ORIGINATION FORM

Proposed Revisions to a Standard Plans Index (Please provide all information — Incomplete forms will be returned)

Index Number: 425-061
Sheet Number (s): 2
Index Title: Closed Flume Inlet

SIDE ELEVATION

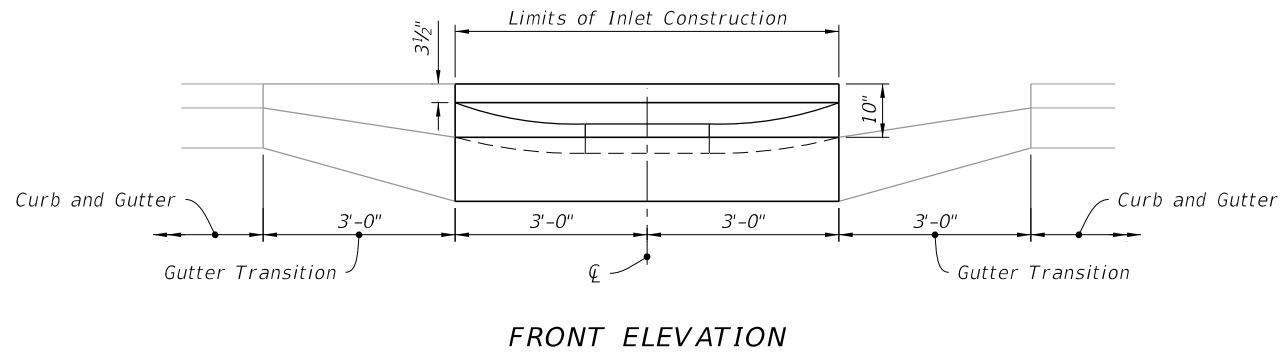
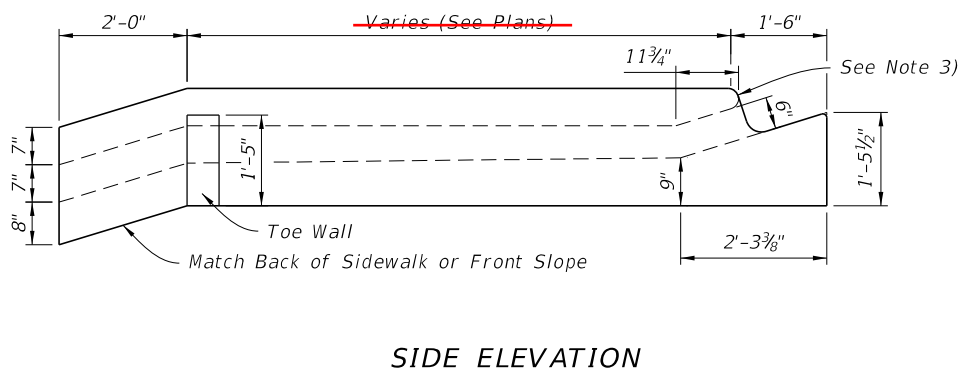
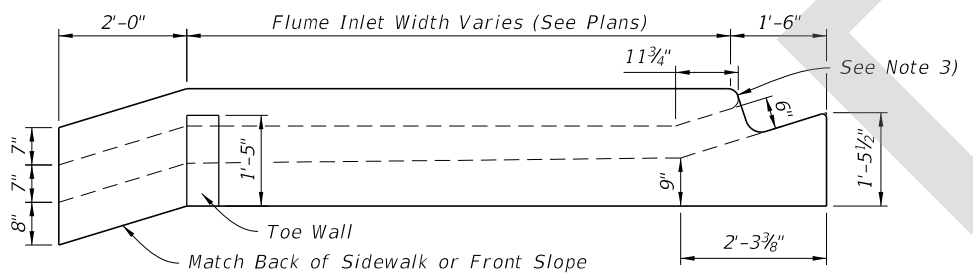
Sheet 2: Revised dimension in Side Elevation detail to "Flume Inlet Width Varies (See Plans)" for clarification on what should be included in the plans. This will also require a clarification in the SPI.

CHANGED TO: Flume Inlet Width Varies (See Plans)

Remove reference to Dimension "D" in SPI and changed text to "Flume Inlet Width"
